JACKSON
ENVIRONMENT AND PLANNING
STRATEGY | INFRASTRUCTURE | COMPLIANCE | PROCUREMENT

Response to Submissions Report
Kariong Sand and Soil Supplies
Sand, Soil and Building Materials Recycling
Facility - SSD8660

Figure 6.3. Updated General Arrangement Plan.

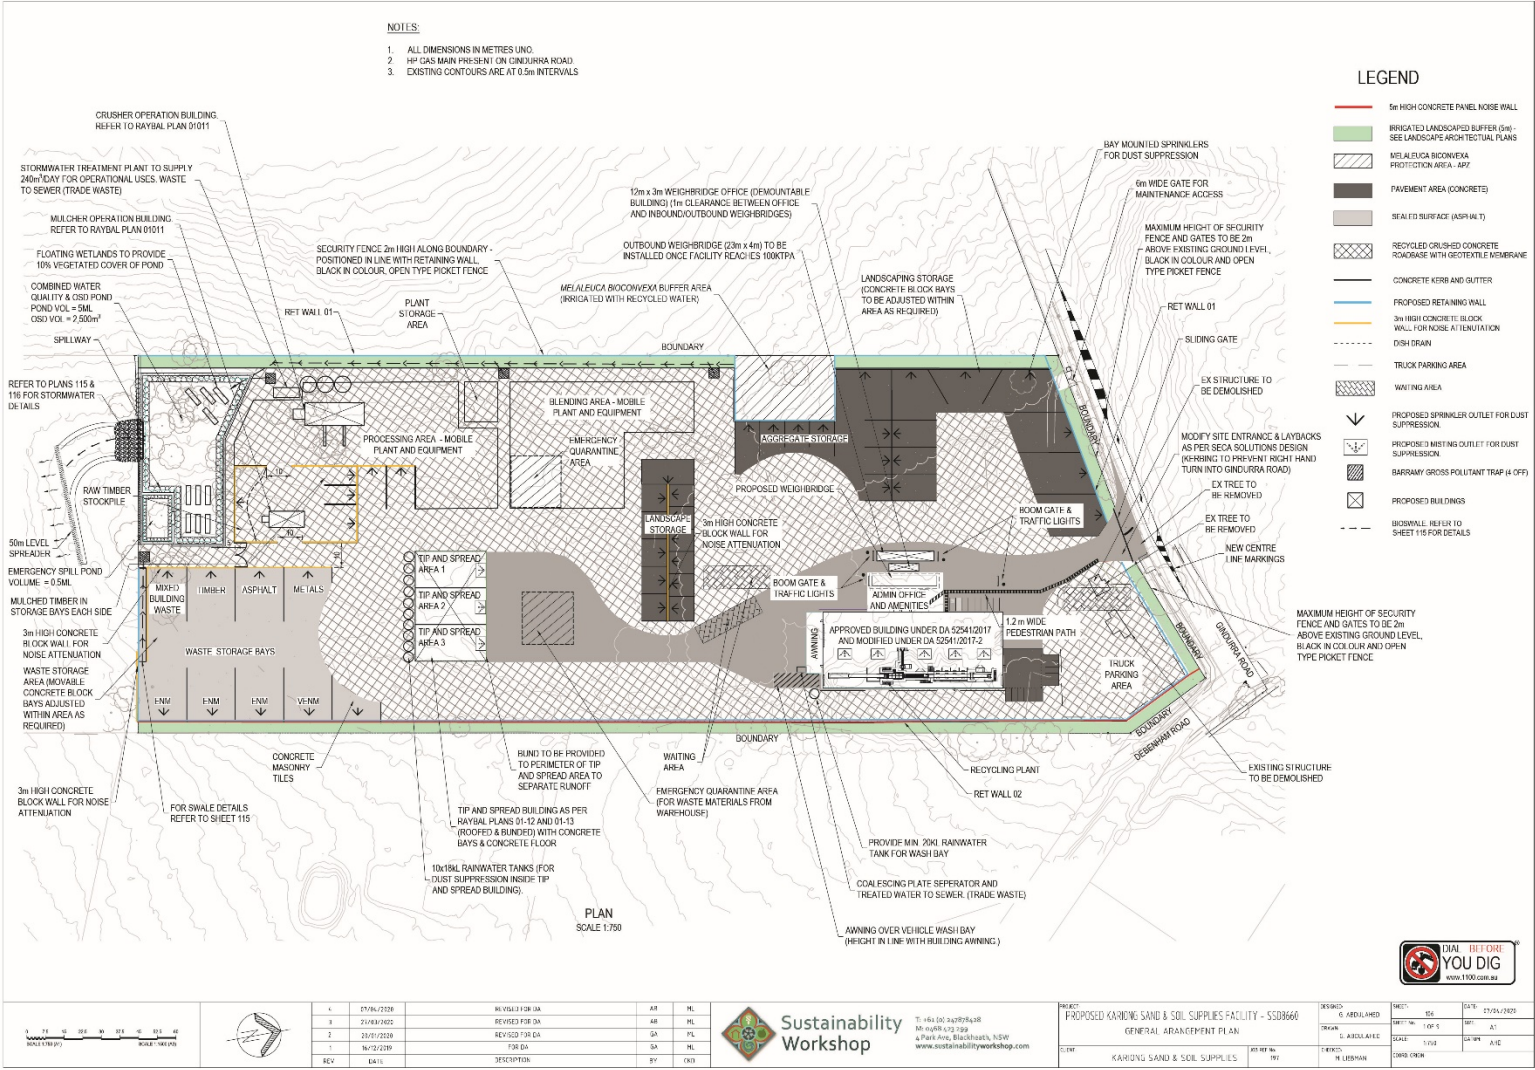
- General Arrangement Plan – showing general site layout and key features
- Civil Works Plan – showing final contours
- Retaining wall sections
- Bulk Earthworks Plan (cut and fill plan)
- Turning Path Plan – showing turning paths for large vehicles on-site
- Detailed Shed Plan – showing details of the Secondary Processing Building
- Stormwater Plan – showing the proposed stormwater capture and drainage system
- Stormwater Sections & Detail – showing the design of the On-site Detention Basin, outlet weir and Bioswales
- Layout and elevation plans for Crusher Building
- Layout and elevation plans for Mulcher Building
- Layout and elevation plans for Tip and Spread Building.
- New hydraulic services plan.

Appendix 2 – Site Layout Plans (before and after changes)

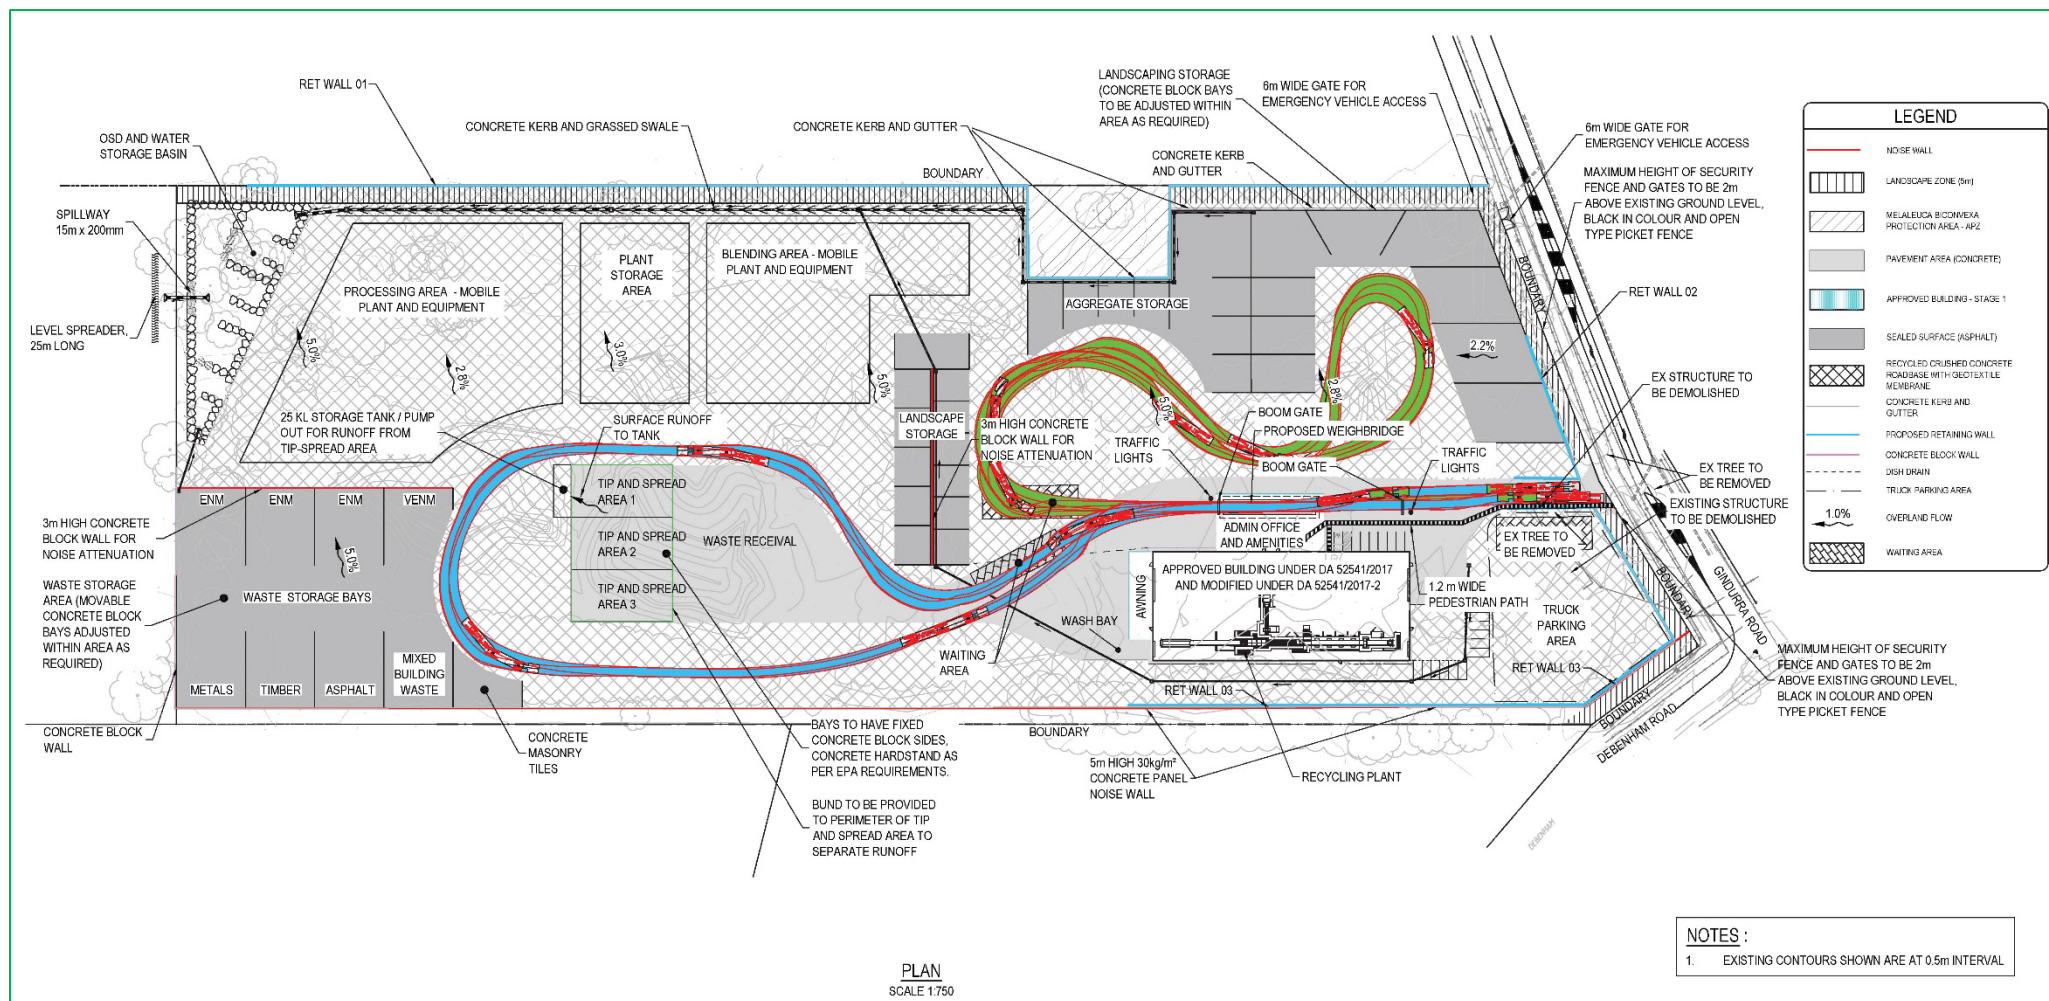
The changes to the plans and figures reflect the changes listed in the section above. Appendix 2 provides copies of the original General Arrangement Plan for before the changes and the final General Arrangement Plan for comparison. The full set of civil plans is provided as an appendix to the revised EIS.

General Site Layout – after changes made in response to comments received during exhibition and community engagement.
